I-85 SEWER EXTENSION  
CONTRACT 1B – COLLECTIONS

ADDENDUM NO. 6

January 10, 2024

Gaffney Board of Public Works  
I-85 Sewer Extension  
Contract 1B- Collections Broad River  
WWTP to Bear Den SPS

C-02-112A

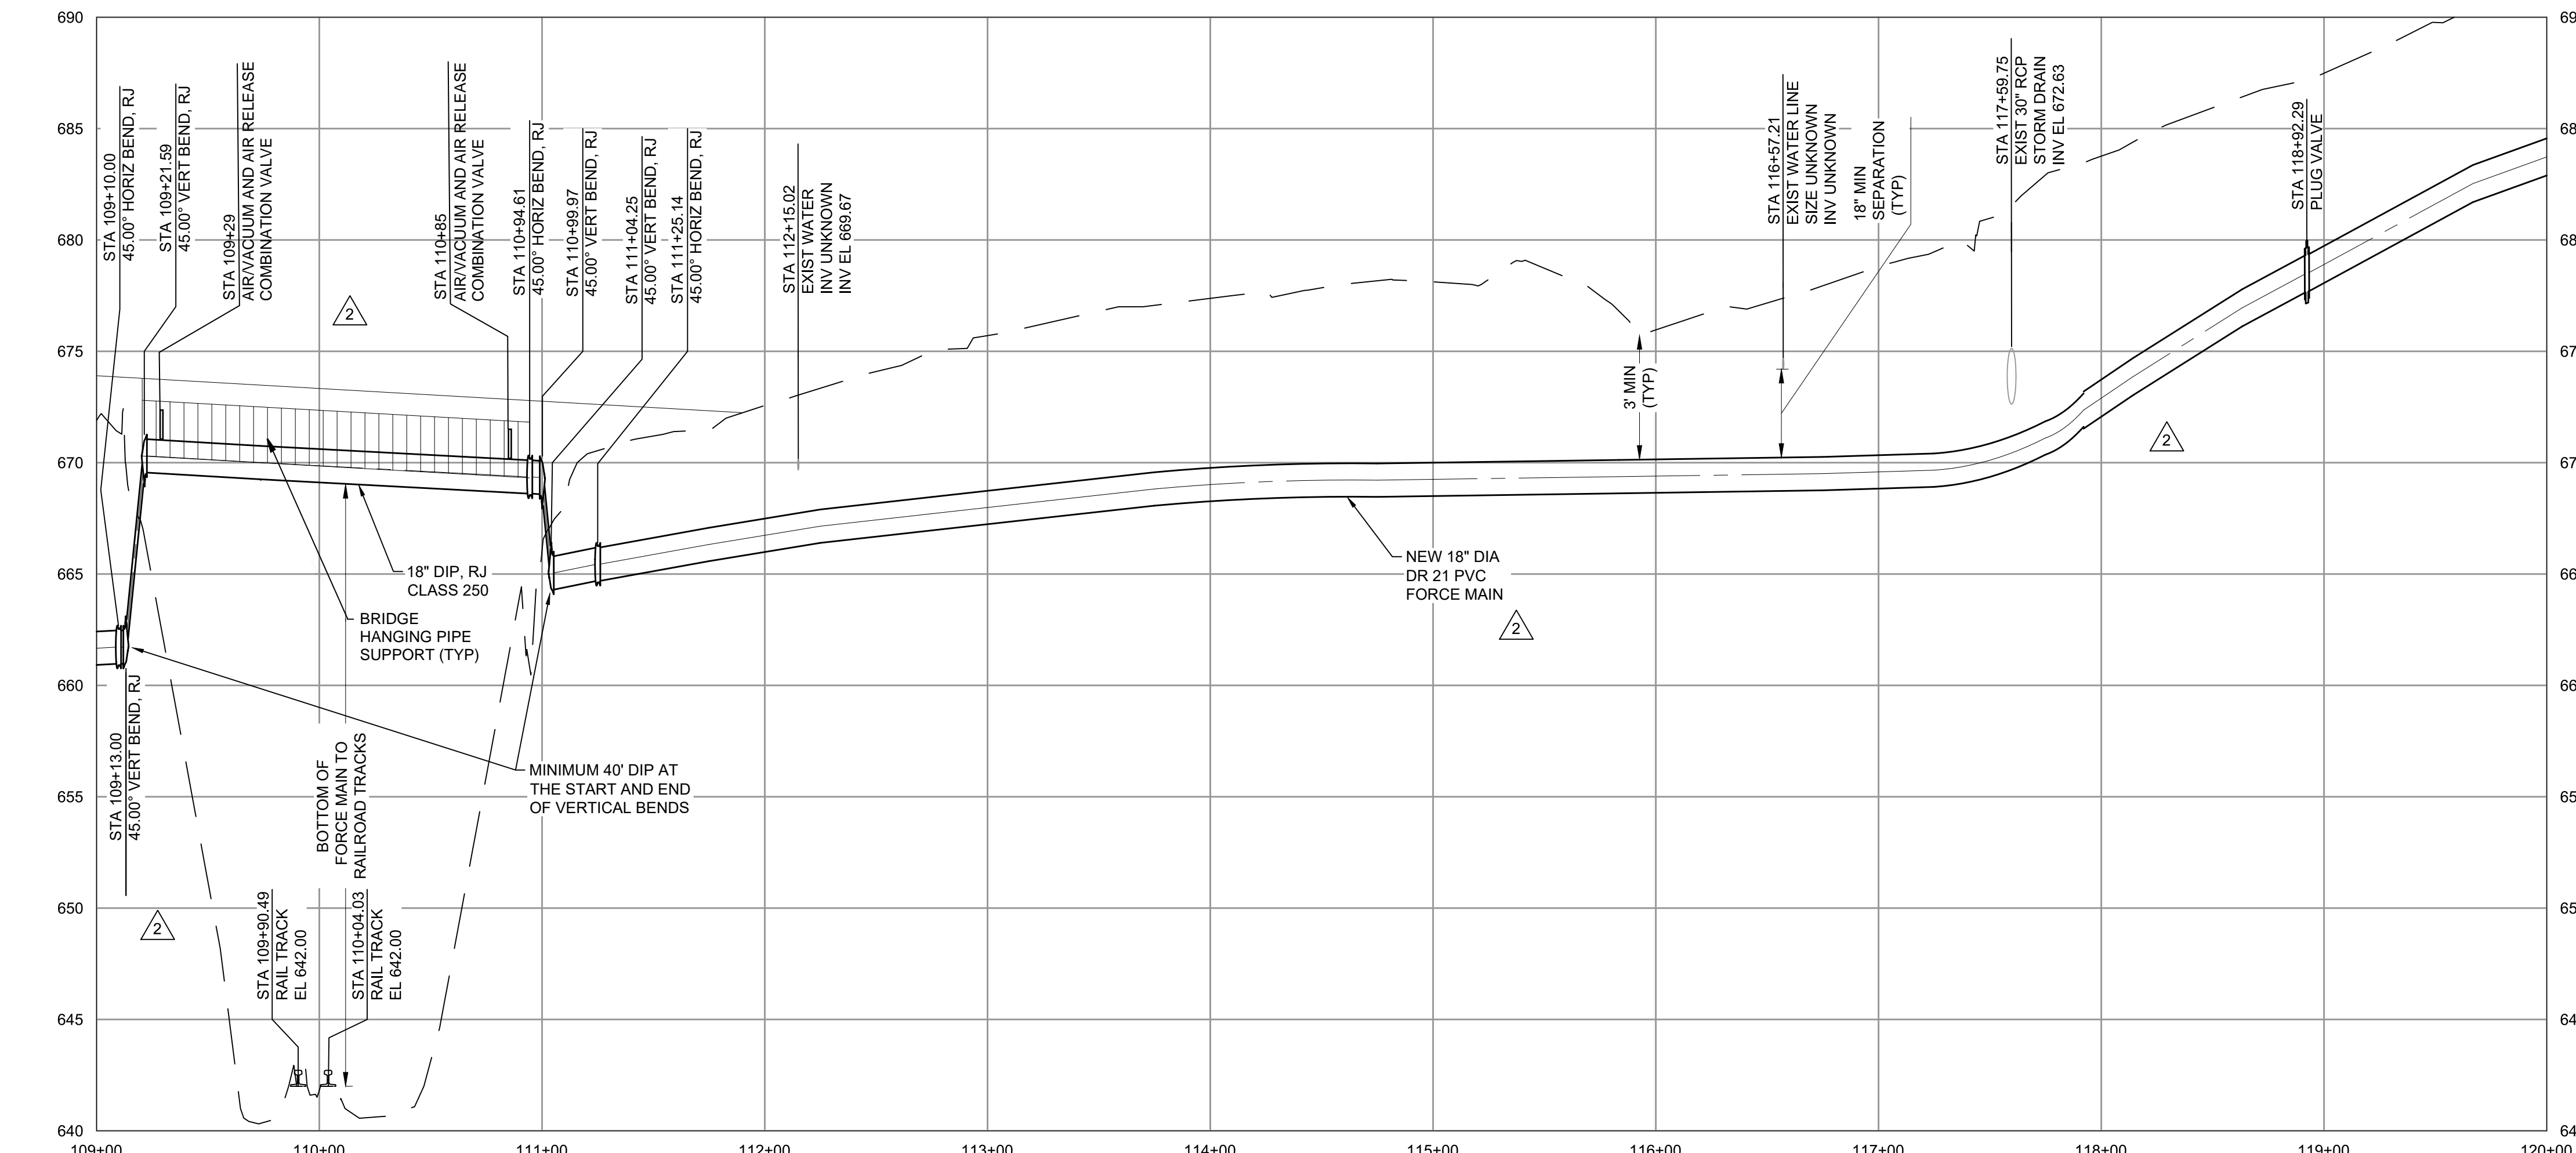
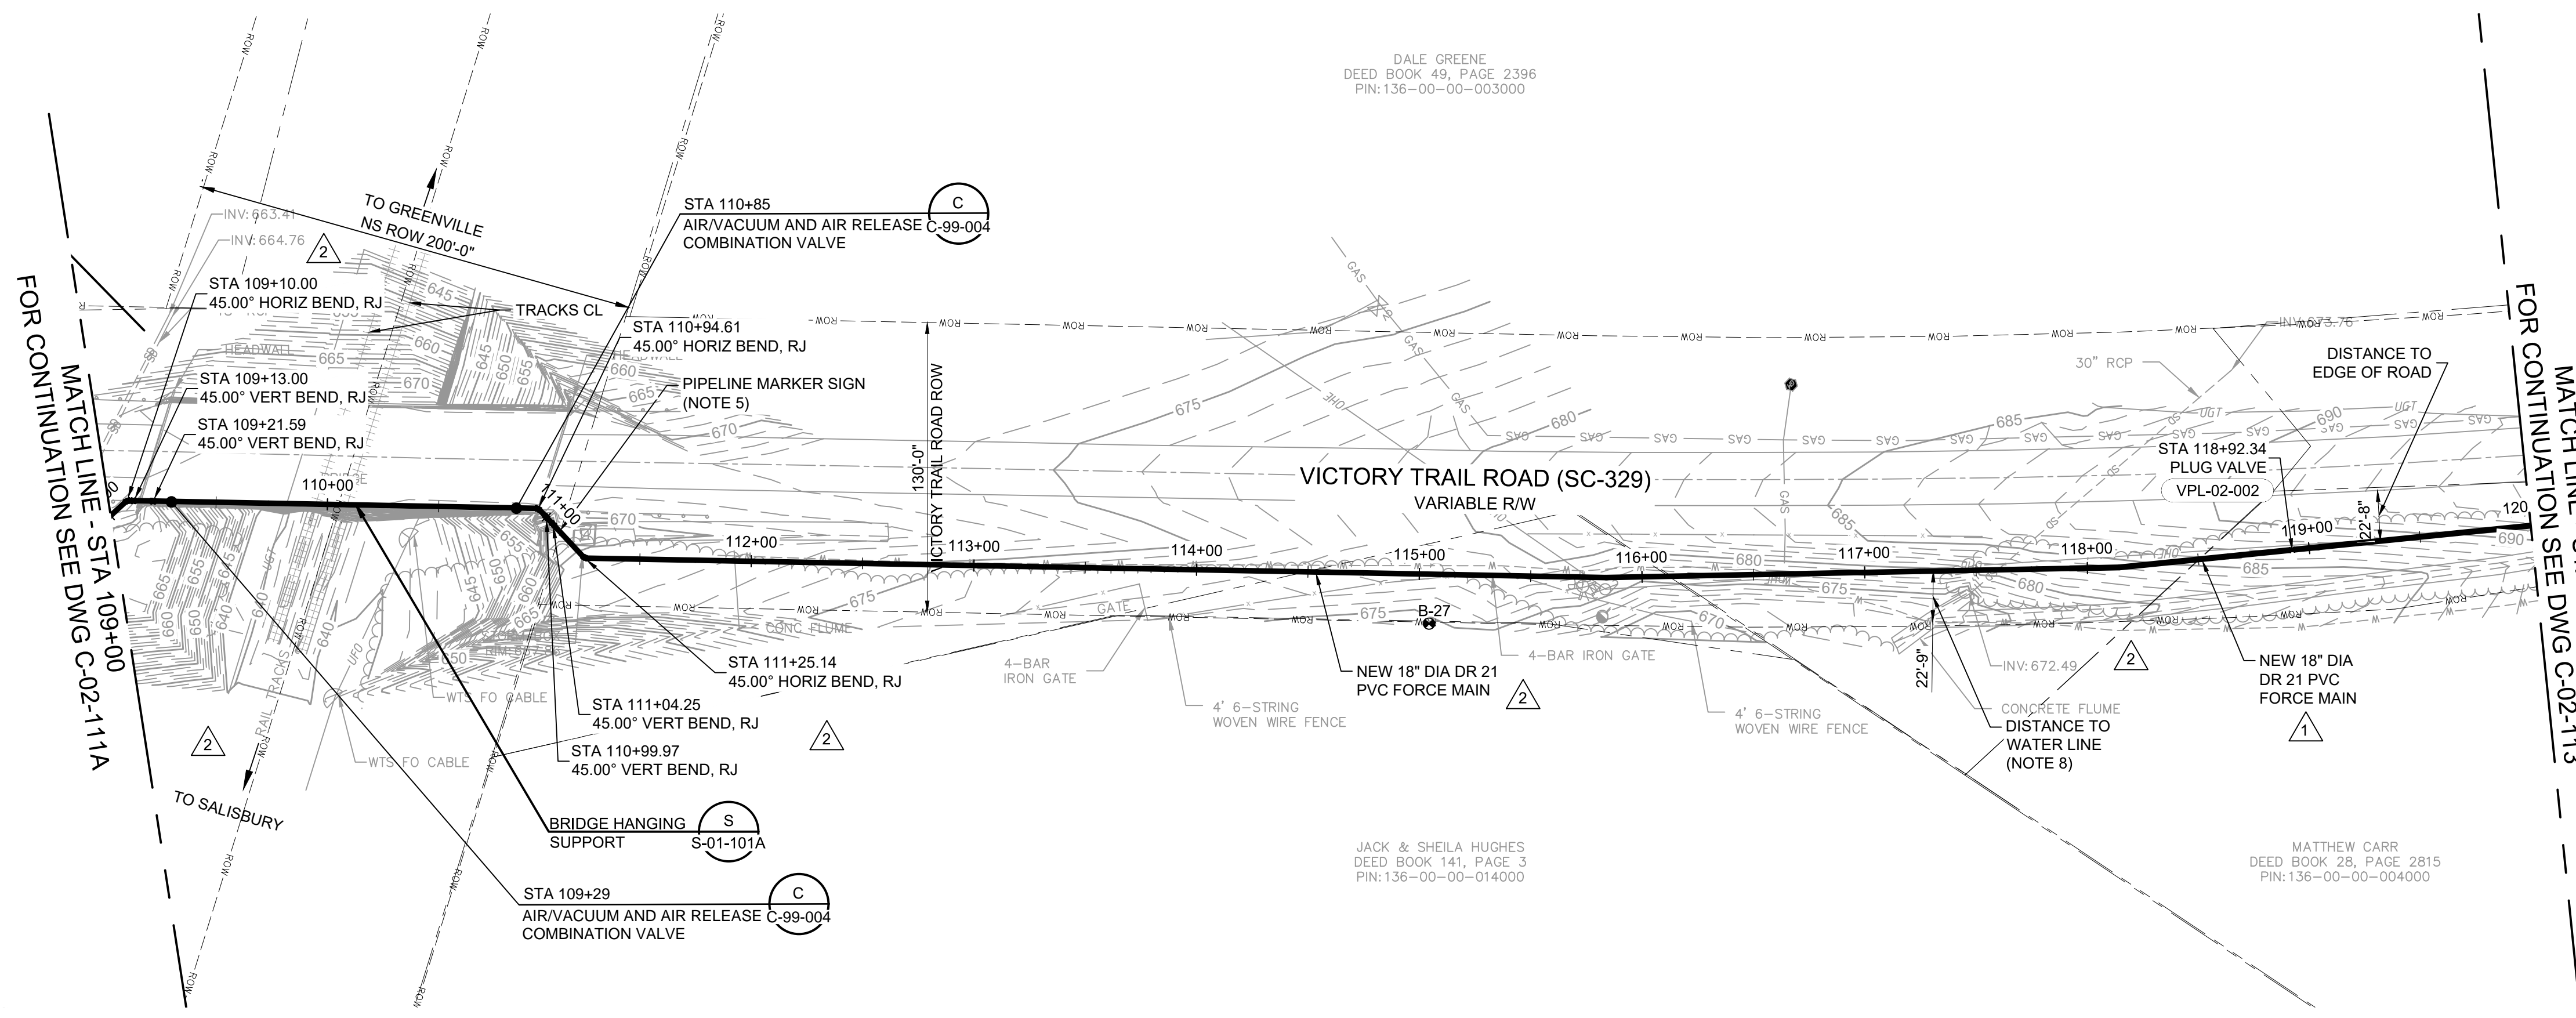
Alternative 1: Removal of Segment 2 horizontal directional drilling and 24” DR 11 HDPE force main under the railroad along Victory Trail Road (Hwy 329). Installation of 18” DR 21 PVC force main with an 18” DIP, RJ Class 250 pipe hanging along the Highway 329 bridge over the railroad.

Remove Segment 2 horizontal directional drilling and 24" DR 11 HDPE force main under the railroad along Victory Trail Road (Hwy 329). Install 18" DR 21 PVC force main with an 18" DIP, RJ Class 250 pipe

hanging along the Highway 329 bridge over the railroad.

- i. Insert the attached new sheets C-02-111A and C-02-112A for Segment 2 Alternative 1 and the new sheets C-03-114A and C-03-115A for Segment 3 Alternative 2 after sheet C-03-120.
- ii. Insert the attached new sheets S-00-001, S-01-101A, and S-01-102A for the Alternatives after sheet C-99-006.
